**GOVERNMENT OF THE DISTRICT OF COLUMBIA
DEPARTMENT OF GENERAL SERVICES**

**DEPARTMENT OF CORRECTIONS ROOF REPLACEMENT
Solicitation Number: DCAM-16-CS-0091
Invitation-for-Bids**

Amendment No. 6

Exhibit 1
Responses to RFI's

8 DOOR THRESHOLD FLASHING
N.T.S

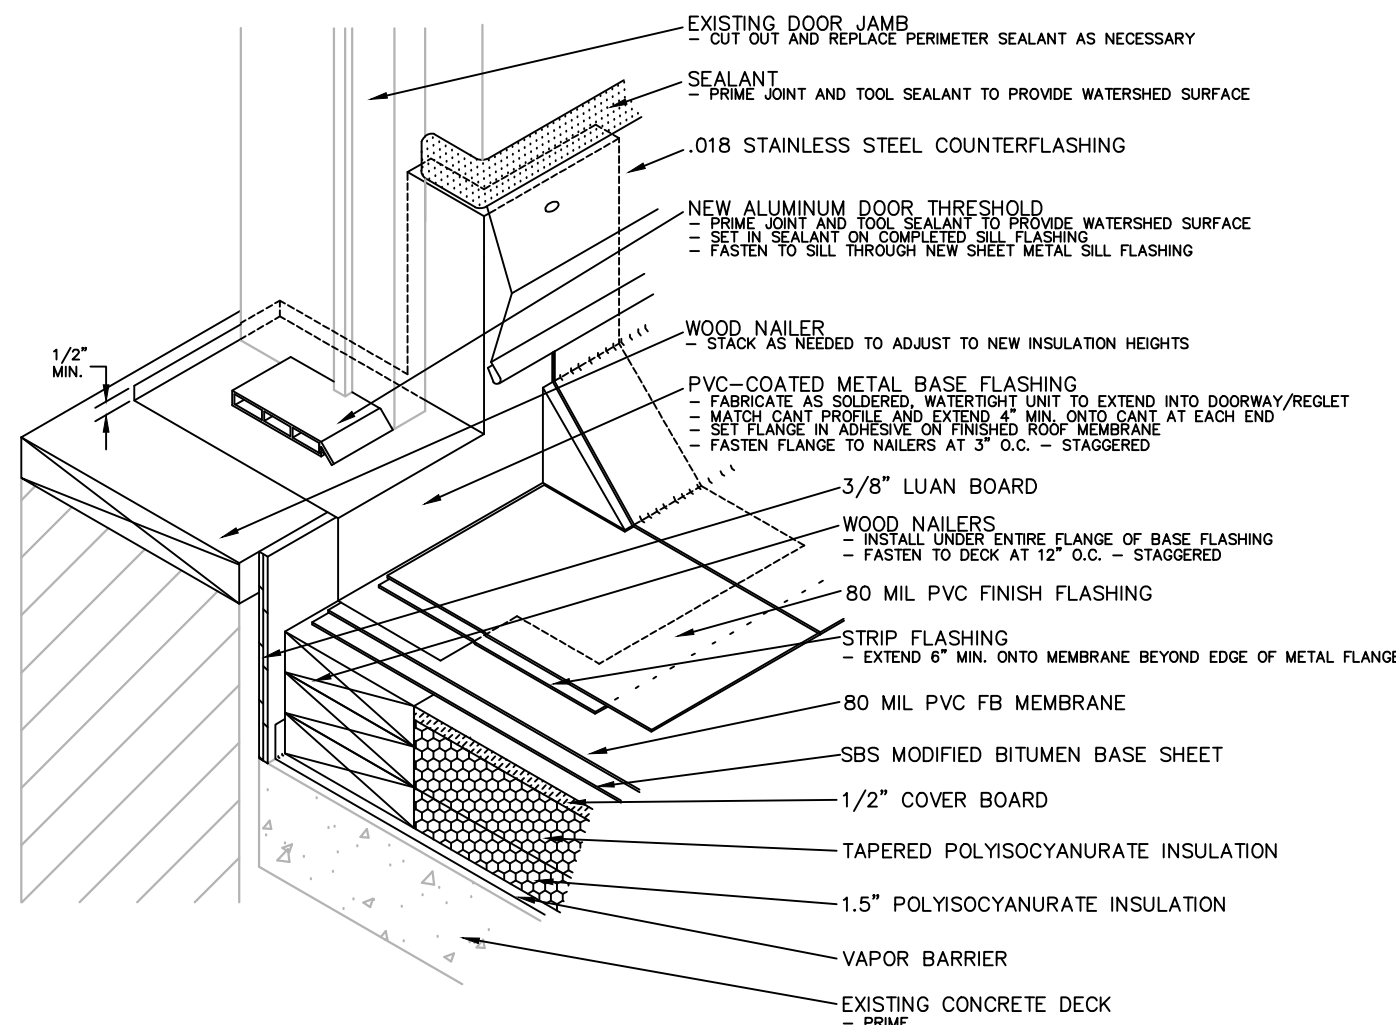
49	Drawing R1.4 - Dlt. 8 Shows sill flashing that appears to go under and behind door frame, but removal of door frame is not indicated. Please clarify.	Contrator will be required to remove the door frame and make any such modifications to install the details as required.
50	Specification Section 03 0100 – Maintenance of Concrete. Specification section is provided, but no locations of repairs or allowance for this work are indicated. Is this section provided to define materials for unforeseen conditions? Please clarify	No concrete replacement is anticipated.
51	Specification Section 05 5213 – Pipe and Tube Railing Systems. Specification is provided, but these are not shown on the drawings. What is the intent of this specification section ?	The manufacturers details are sufficient for bidding. The manufacturer will be required to provide submittals prior to commencement of the work. The areas of installation are shown on the Phase 2 Roof Plan,

6 TYPICAL ROOF ASSEMBLY TYPE 2 ROOF
N.T.S

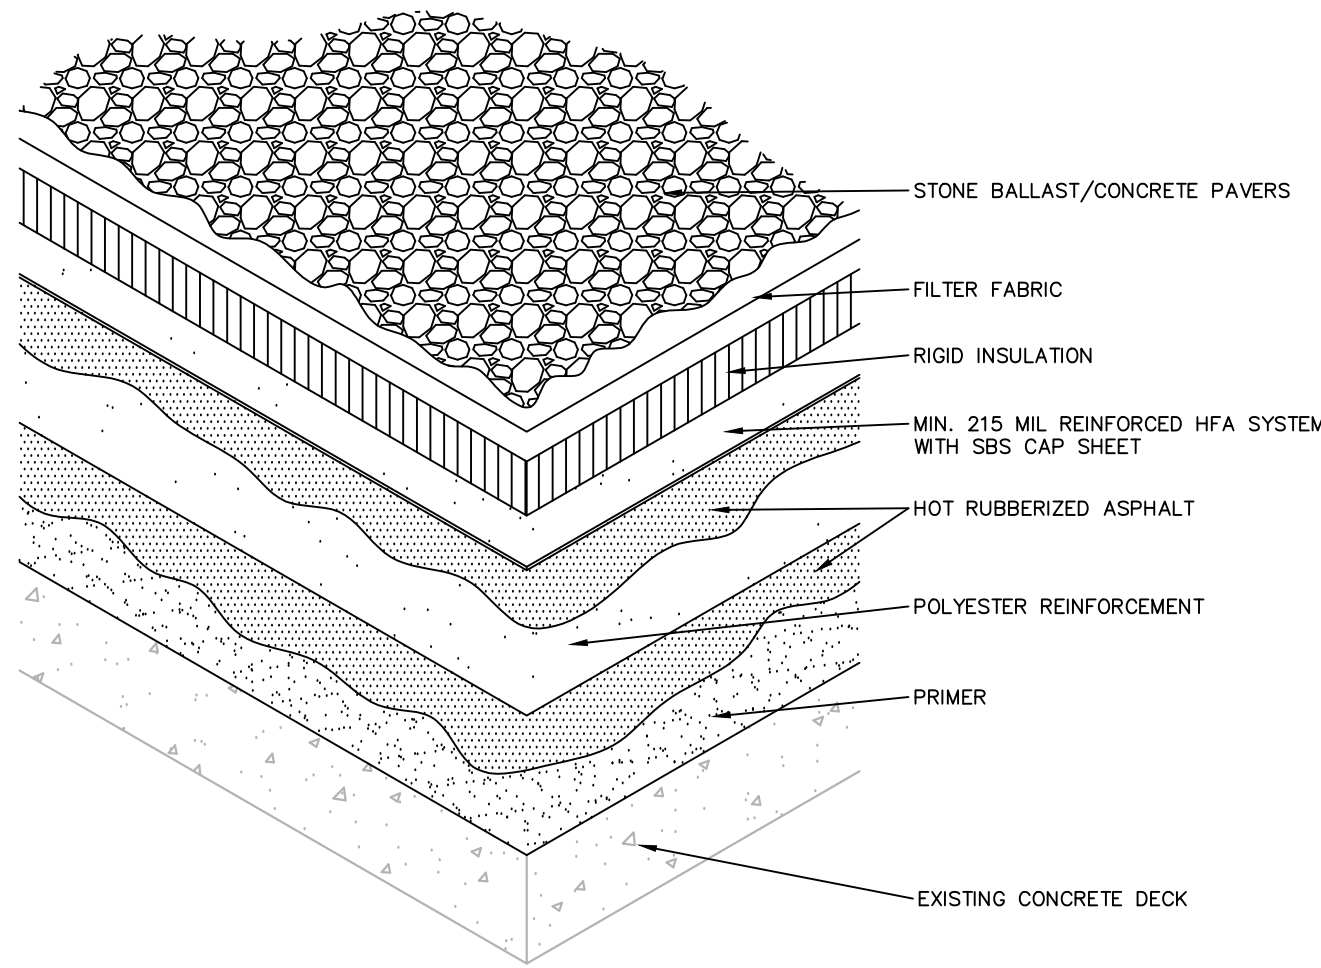
23	Spec 071401-2.03-I Insulation – Please provide the required thickness of Extruded Insulation for the HARA System	Detail 6 of R 1.8 is the assembly with 4" XPS
24	Spec 071401-2.03-K.1 & K.2 Topping Materials – Specification calls out Architectural Pavers and mentions Roofing Ballast. Which material is to be utilized on top of the Extruded Insulation ?	Detail 6 of R 1.8 is the assembly with 4" XPS - Pavers are only to be applied at access points (Ladders, Doors and RTU Maintenance Panels, in accordance with the Manufacturers Specifications.
25	Spec 071401-2.03-K.1-6 Architectural Paver Color and Finish – Provide information or confirm if the manufacturer's typical utility paver can be installed?	Standard Manufacturer's buff diamond finish.

40	Can the dumpsters stay in place overnight during the tear off or do they have to be pulled off site at the end of each day.	Yes, the dumpsters can stay in place overnight.
41	Can we keep gang boxes on the roof with tools during the roofing project?	Yes, in the penthouse.
42	Can you send pictures of the roof overviews and details?	Please see condition assessment report.
43	Is there a layout for the paver walkways & the units where you want the pavers installed.	Pavers are only to be applied at access points (Ladders, Doors and RTU Maintenance Panels, in accordance with the Manufacturers Specifications.
44	How many plies of the SBS modified membrane is required for the hybrid roof?	The Hybrid Manufacturers' only require (1) ply
45	Can you clarify the exact assembly for the hot fluid applied roof? (Type 2 roof) (specs call for insulation, how thick does the insulation need to be?)	Detail 6 of R 1.8 is the assembly with 4" XPS
